1. SUBMITTAL TYPE: (Is this a resubmittal? Yes ☐ No ☒)			
Deferred Submittal ☐	Addendum Number: 01	Revision Number:	CCD Number: Category A ☐ or B ☐
2. PROJECT INFORMATION:			
School District/Owner: San Beranrdo City USD		DSA File Number: 36 H7	
Project Name/School: Indian Springs HS - Health Center		DSA Application Number 04 123900

ADDENDUM NO. 1

Indian Springs High School – Health Center

DSA #04-123900 FILE #36-H7 RCA Project No. 1-78-50

ROOF FRAMING PLAN
SCALE: 1/8" = 1'-0"

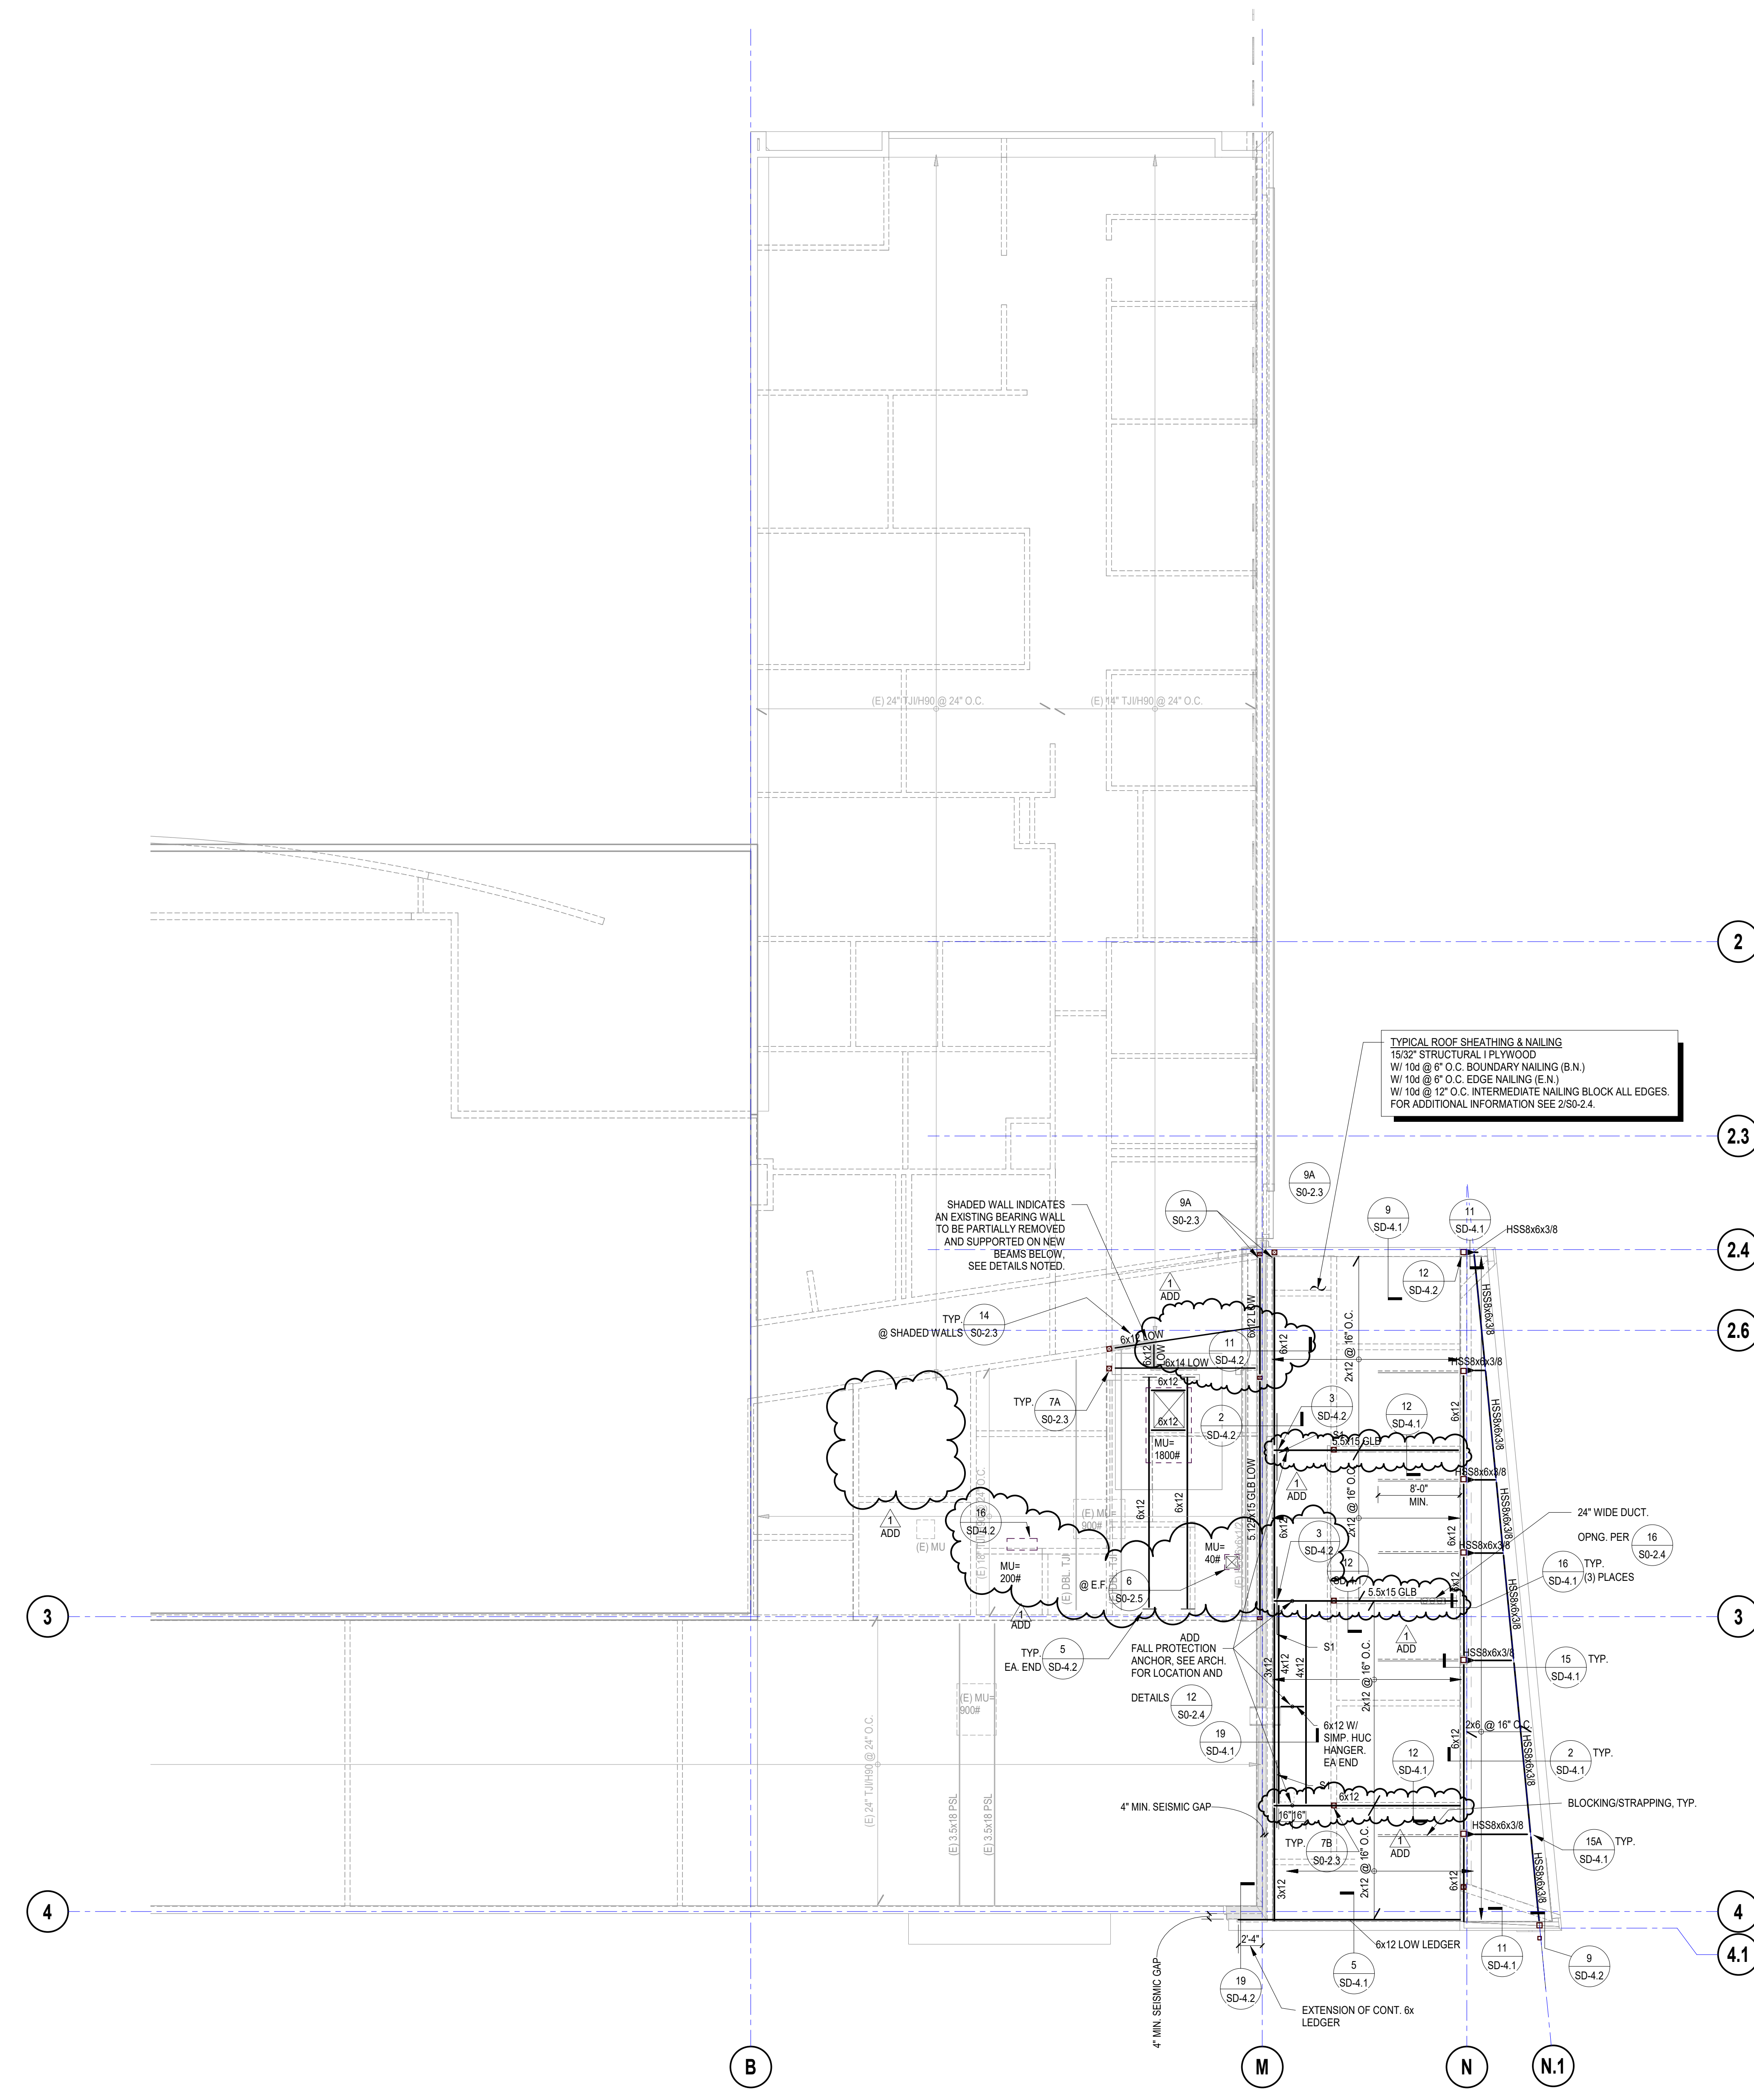
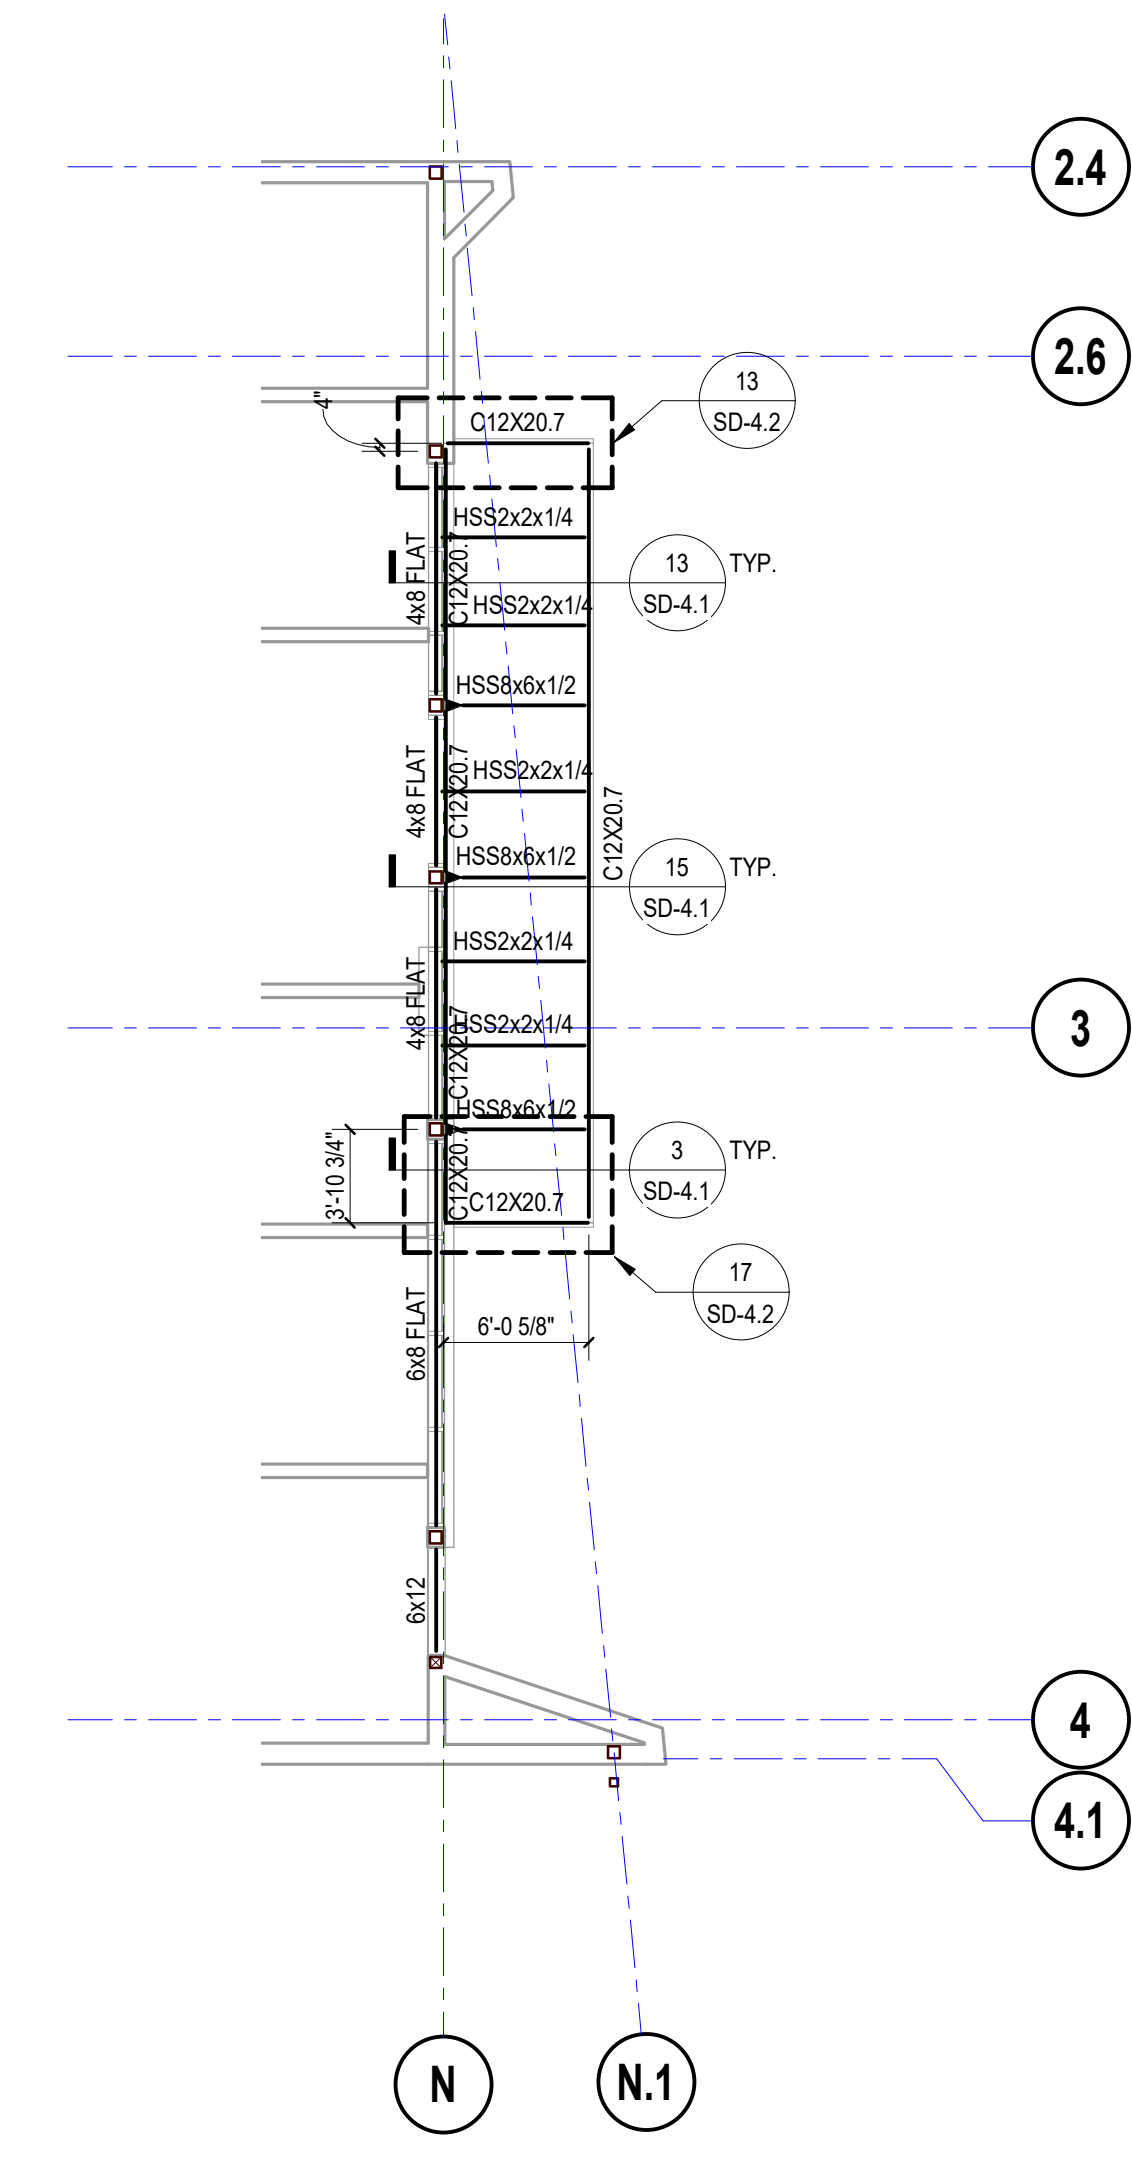
- Item No. 1.24 Reference Sheet S1-3.1 - ROOF FRAMING PLAN
- 1.24.1 Replace Sheet S1-3.1 and revise per clouded areas & items listed below:
- (a) Revised Roof Framing Plan in coordination with Architectural & MEP changes

MECHANICAL REMODEL FLOOR PLAN

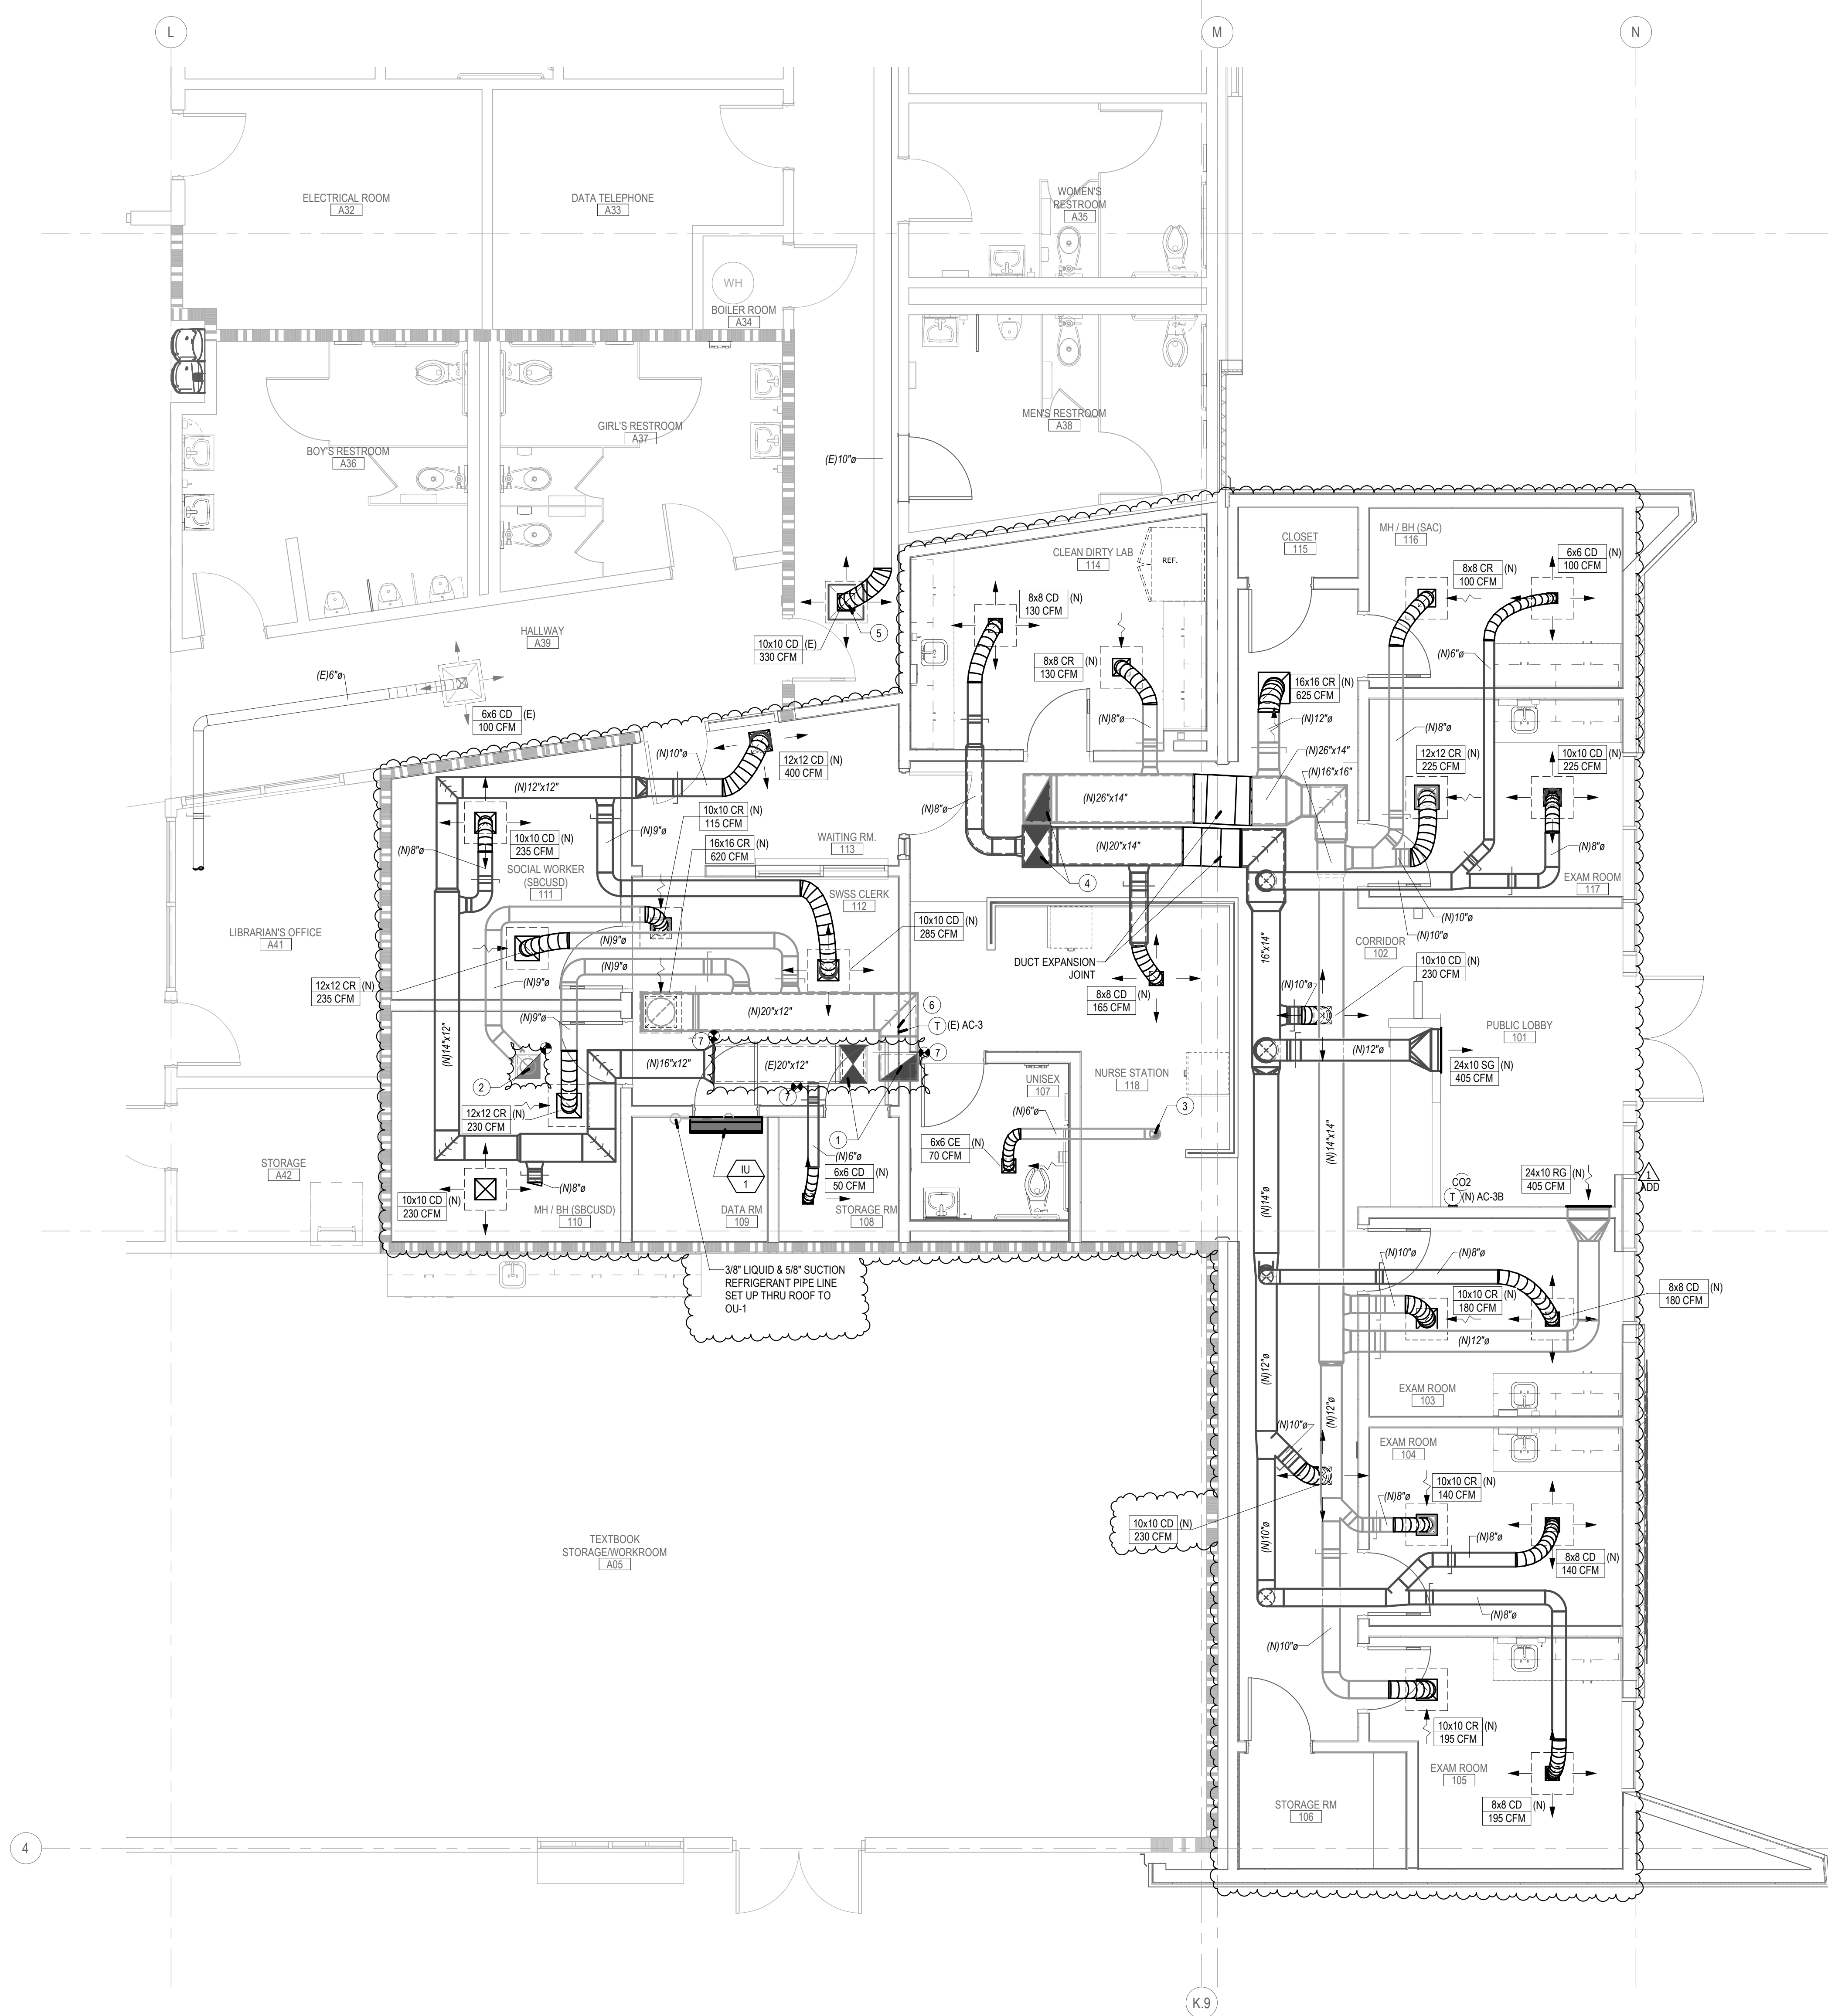
Item No. 1.31 Reference Sheet M1-1.1 - MECHANICAL REMODEL FLOOR PLAN
1.31.1 Replace Sheet M1-1.1 and revise per clouded areas & items listed below:
 (a) Revised air distribution for AC-3 and AC-3B
 (b) Revised location of existing thermostat for AC-3
 (c) Revised location of new thermostat and CO2 sensor for AC-3B
 (d) Revised location of new exhaust duct thru roof
 (e) Added new IU-1 and refrigerant piping
 (f) Added new general notes #15 & #16
